**(1) What is size of the Gasifier void/s at the Linc Energy Site?**

(2) What is the nearest distance between the proposed well/s (Stage 2) to the site boundary (Lot 40 DY 85)?

**Figure 2 – Northwest-southeast cross-section of HSUs, groundwater levels and concentration at the end of 2025**

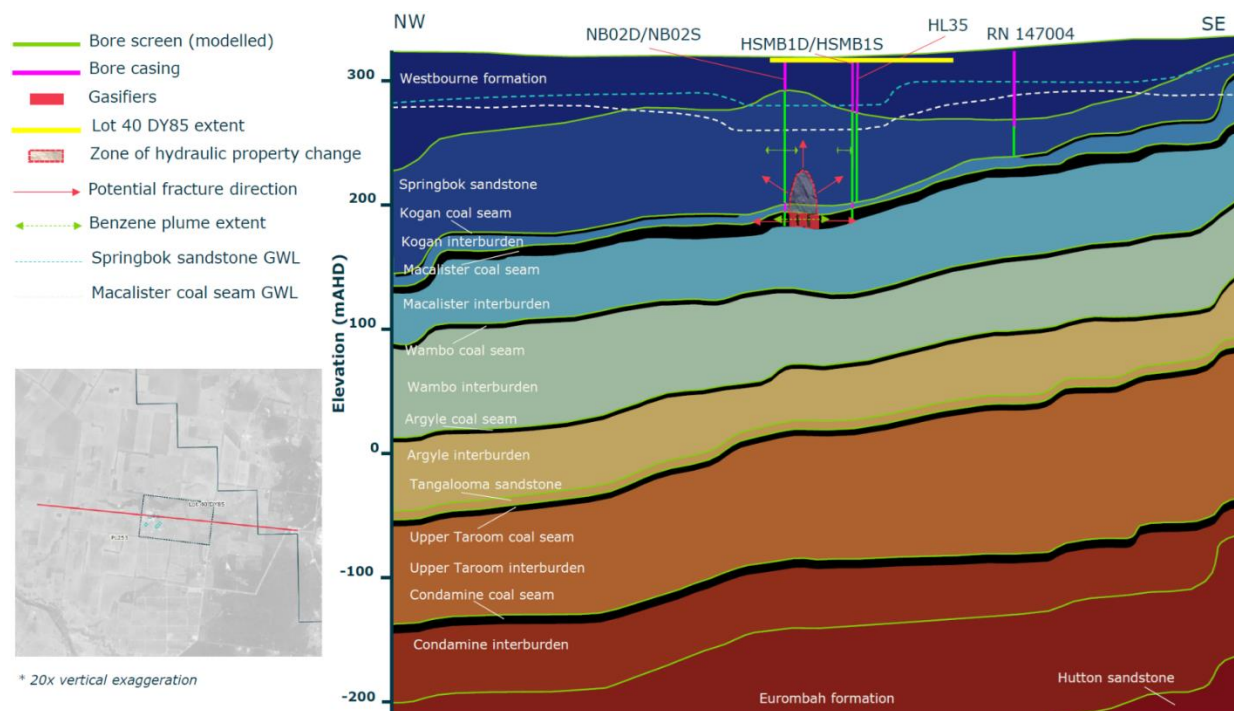
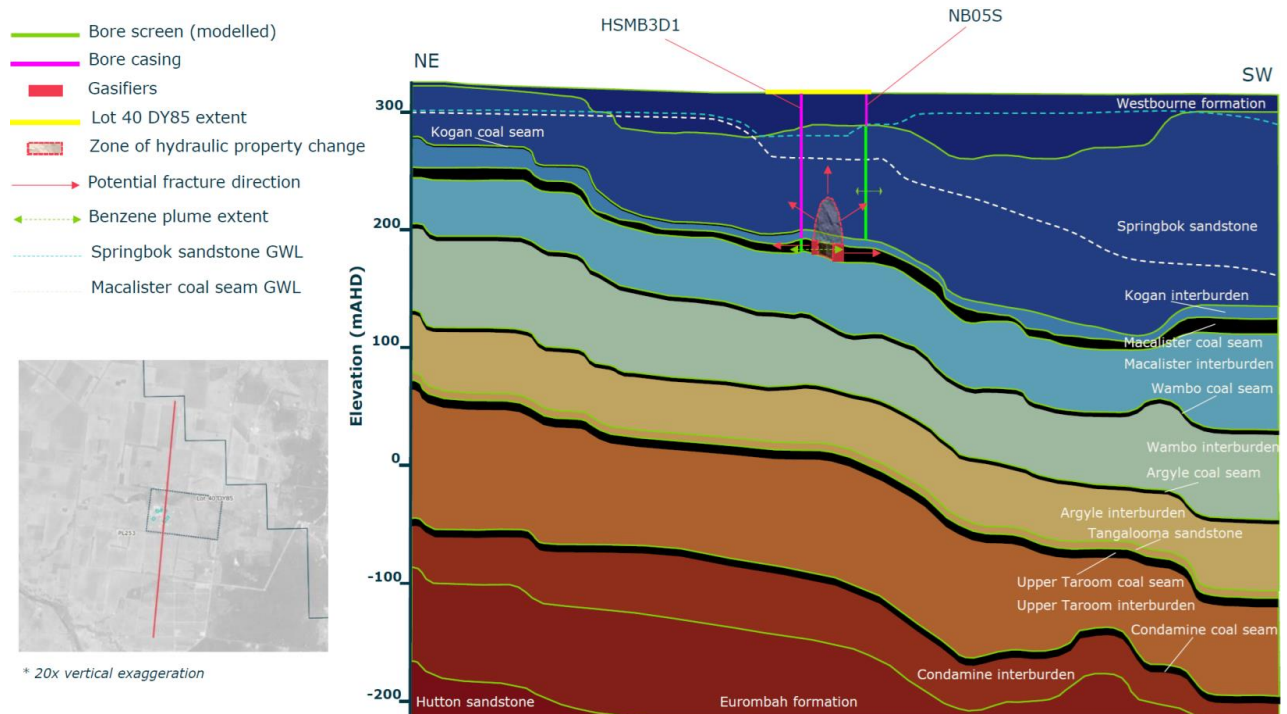
(5) Poor cross-sectional display of the conceptual model diagram (figure 2-1). CSM display needs to be improved. The conceptual model should display void at the Linc Site, site boundary, major hydro-stratigraphic units, monitoring wells, current hydraulic head in the monitoring well (in mAHD), current plume extent and key groundwater receptors (e.g. water

supply wells). A minimum of two cross-sections (one east-west and another north-south) would be required.

Two cross-sections (Figure 2 and Figure 3) have been added to expand on the conceptual site model (CSM) presented in Section 2.1 of the EA amendment report.

The cross-sections explicitly incorporate the legacy of UCG operations. Note that the initial contaminant placement at the Linc site did not occur via groundwater flow, but rather through high pressure, high temperature gas-phase migration and subsequent condensation within and adjacent to the gasifier voids. This is consistent with the site conceptualisation, where UCG operations (1999–2013) resulted in hydrocarbon by-products being introduced into surrounding strata under elevated pressure and temperature conditions, with associated fracturing and disturbance of overlying units (Section 2.1 of the report). To reflect this, the cross-sections (Figure 2 and Figure 3) include:

- The gasifiers and overlying altered zone, representing thermally and mechanically modified strata with changed hydraulic properties due to UCG-induced fracturing and material removal (consistent with Section 3.1.3.7 of the report),
- Major hydro stratigraphic units (18 layers represented in the groundwater model, consistent with Section 3.1.2),
- Monitoring wells, with current hydraulic heads (mAHD) based on end 2025 conditions (consistent with Section 2.4.1),
- The current plume extent, which reflects initial contaminant placement mechanisms (gas-phase migration and condensation during UCG operations) and attenuation, and
- Key groundwater receptors (e.g. landholder bore RN147004).

Overall, Figures 2 and 3 integrate the EA amendment CSM (Section 2.1 of the report), including the gasifiers, altered zone, hydrostratigraphy, monitoring data (heads), plume extent, and receptors (see also answer to question 9 below on potential groundwater receptors).

**Figure 4 – Median groundwater levels around Lot 40 DY85 in the Springbok sandstone**

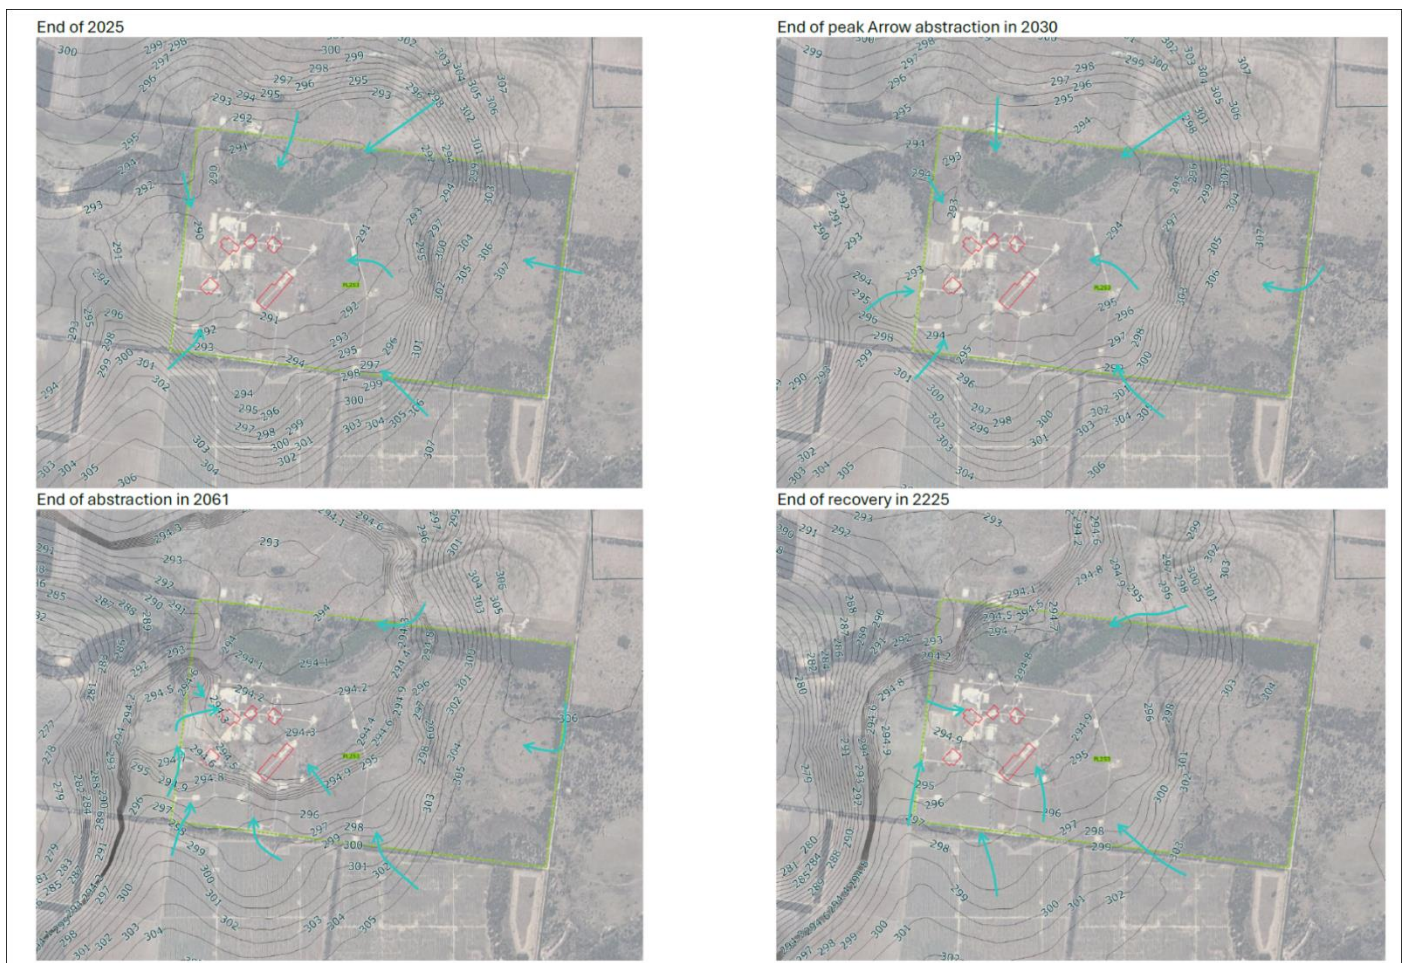
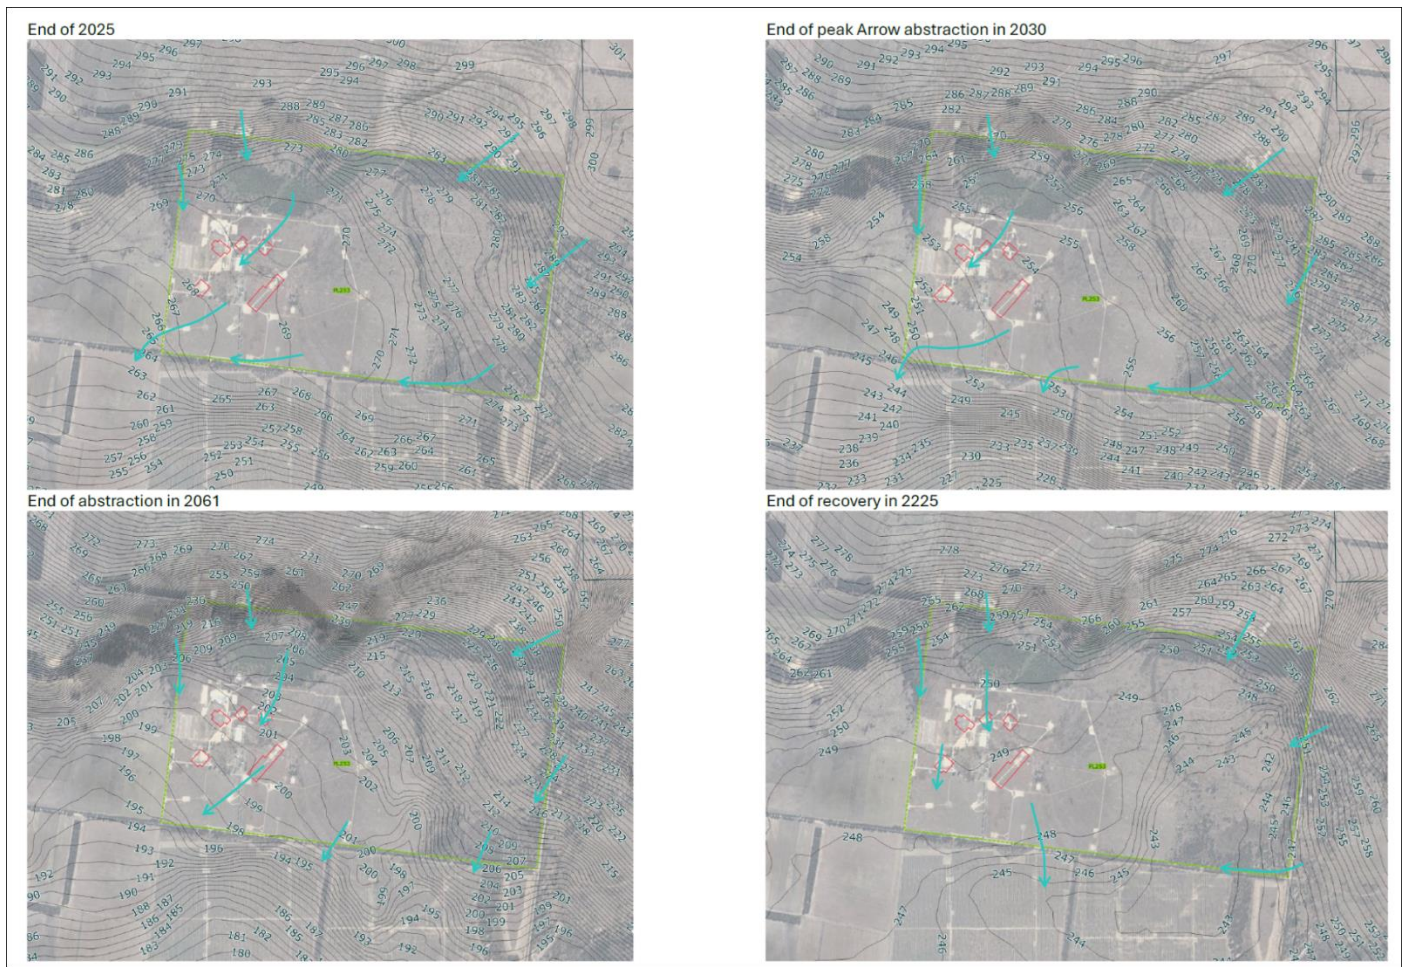
(11) Timing of horizontal hydraulic gradient reversal has not presented in the report.

To assess the timing of horizontal hydraulic gradient reversal, median groundwater level contours for the Springbok sandstone and Macalister coal seam, constructed using simulated groundwater levels, were presented across the posterior ensemble at selected times during the abstraction and recovery periods (Figure 4 and Figure 5). Flow reversal was identified where outward hydraulic gradients developed along a substantial portion of the Lot 40 DY85 boundary.

In the Springbok Sandstone (Figure 4), inward flow toward Lot 40 DY85 persists through to the end of the recovery period (2225). This is due to the vertical flow direction between the Springbok sandstone and the underlying Macalister coal seam (near historical gasifiers) driven by CSG abstraction and ongoing recovery within the WCM.

In the Macalister coal seam (Figure 5), model results indicate that flow reversal occurred prior to 2026, consistent with recent observed groundwater levels. Groundwater flow enters Lot 40 DY85 from the northern and eastern boundaries and exits at the southwestern corner. From the end of peak abstraction (2030) through to the end of the recovery period, the direction of flow leaving the site shifts progressively toward the south.

**Figure 6 - Predicted vertical hydraulic gradient between the Macalister coal seam and Wambo coal seam at paired monitoring locations**

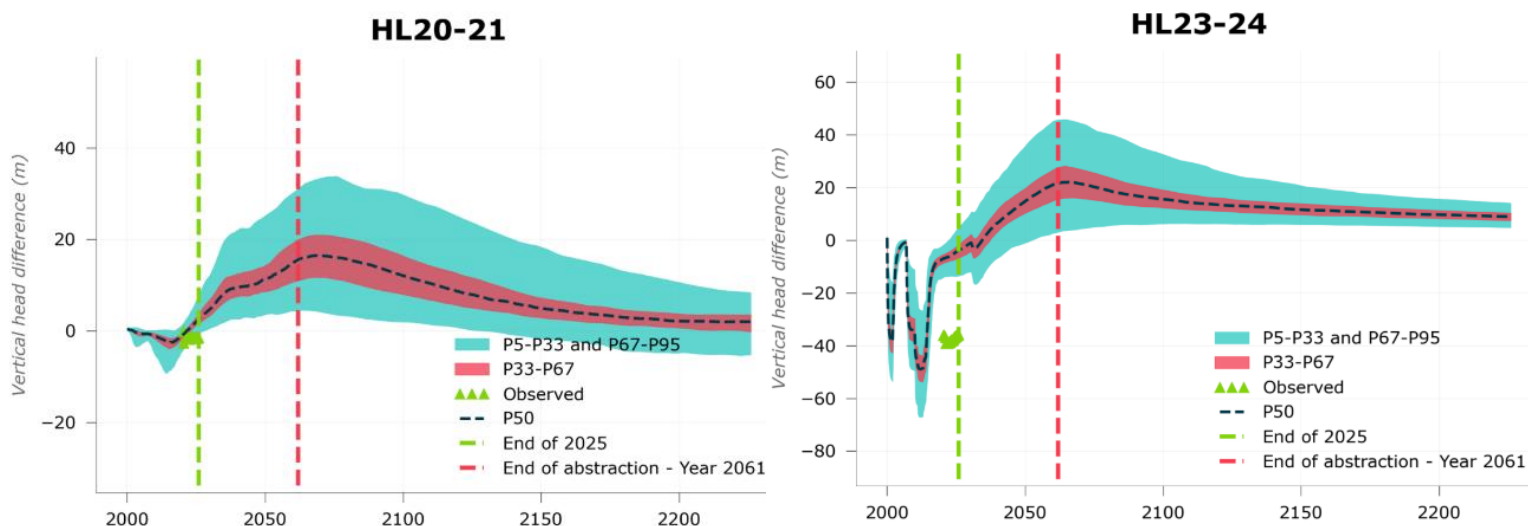
- (12) As per the report, the vertical gradient reversal is not expected in between the McAlister Seam and Springbok. What about the vertical gradient between the McAlister Seam and the underlying formation?

To further assess the vertical gradient between the Macalister and Wambo coal seams, simulated vertical head differences are presented for three distinct phases: pre-development (pre-2026), production/depressurisation (2026 to approximately 2060), and post-closure recovery (post-2060) for the monitoring bore pairs (Figure 6).

During the pre-development phase, the simulated vertical head difference remains negative, consistent with observed data, confirming an upward gradient from the Wambo coal seam to the Macalister coal seam. This agreement indicates that the model is satisfactorily calibrated and capable of reproducing the existing flow regime.

Following the commencement of CSG extraction from the coal seams in 2026, the model predicts a rapid transition to a positive vertical head difference. This indicates a reversal of the natural gradient, with a downward hydraulic gradient from the Macalister coal seam to the Wambo coal seam during the production phase. The largest head differences, and therefore the strongest downward gradients, occur during the mid-production period, as demonstrated by the HL20–HL21 and HL23–HL24 bore pairs. This reversal of hydraulic gradient in the coal seams is also observed by OGIA:
